SOUTH CENTRAL WATERFRONT COMBINING DISTRICT & DENSITY BONUS PROGRAM (DRAFT – Staff Recommendations)

PLANNING DEPARTMENT
CITY OF AUSTIN

Figure 3.2: SCW Subdistrict and Floor-to-Area Ratio Map

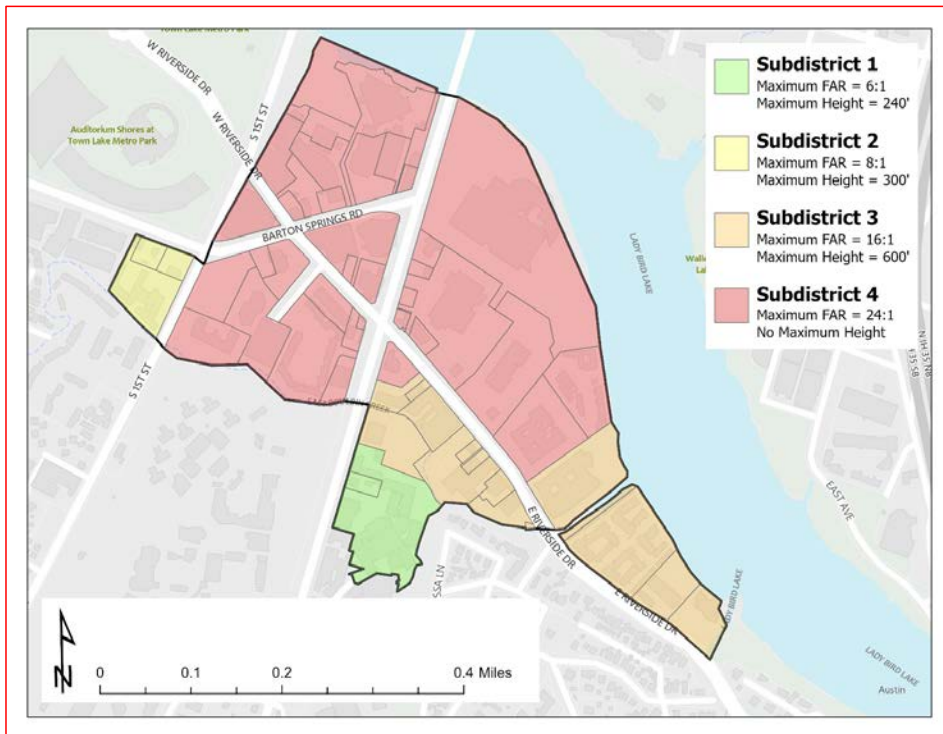
Commented [MS1]: Planning Commission Recommendation: Remove Subdistrict 1 and renumber:

~~Subdistrict 1:~~

~~The lowest density subdistrict, Subdistrict 1 serves as a transitional buffer between existing low density residential to the east and the subsequent low medium density of Subdistrict~~

~~The boundaries of Subdistrict 1 shall apply to the portions of property no less than 250 feet from the public right of way along South Congress Avenue.~~

- ~~a. The maximum floor to area ratio is 3:1.~~
- ~~b. The maximum building height is 120 feet.~~

Staff recommends this amendment.

Figure 4.1: Internal Circulation Route Option 1 Cross Section

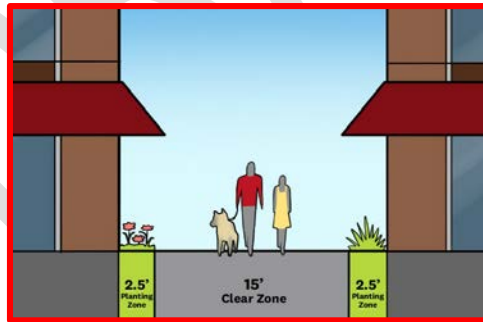
Commented [MS5]: Planning Commission Recommendation: Increase from 10-foot to 15-foot.

Figure 4.2: Internal Circulation Route Option 2 Cross Section

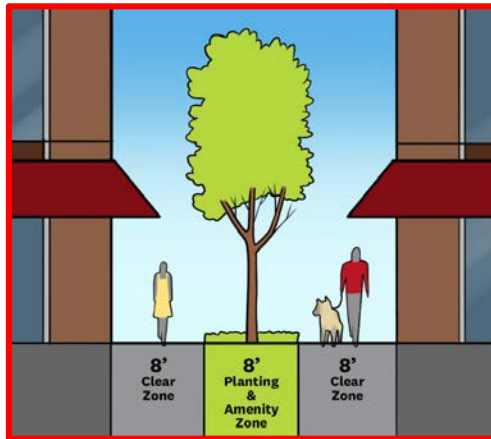
Commented [MS6]: Planning Commission Recommendation: Expand the clear zone from 5 to 7.5 feet on each side. This recommendation was increased to 8 feet to comply with the Americans with Disabilities Act.

Commented [MS7]: Staff recommendation for shade trees.

Figure 4.3: Internal Circulation Route Option 3 Cross Section

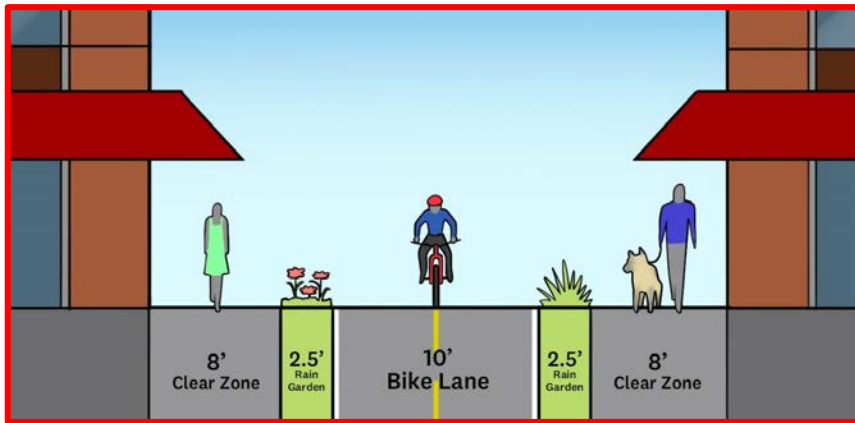
Commented [MS8]: Planning Commission Recommendation: Expand the clear zone from 5 to 7.5 feet on each side. This recommendation was increased to 8 feet to comply with the Americans with Disabilities Act.

Commented [MS9]: Staff recommends change to rain garden(s) from planting zone(s).

Figure 4.4: Internal Circulation Route Option 4 Cross Section

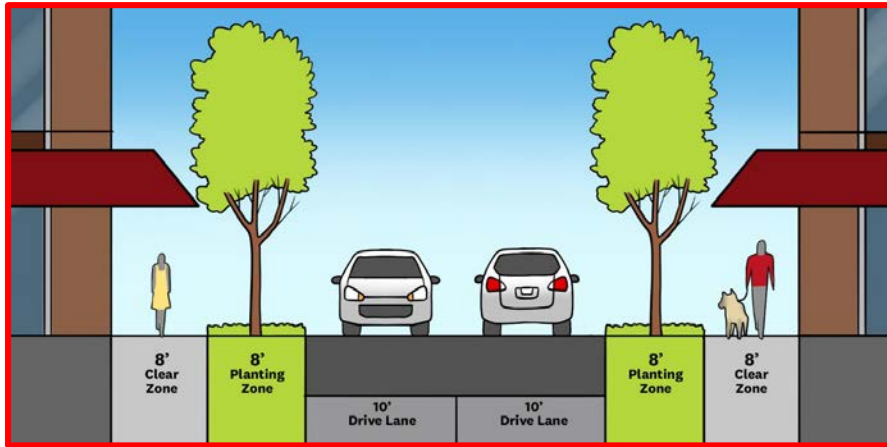
Commented [MS10]: Staff recommendation for shade trees.
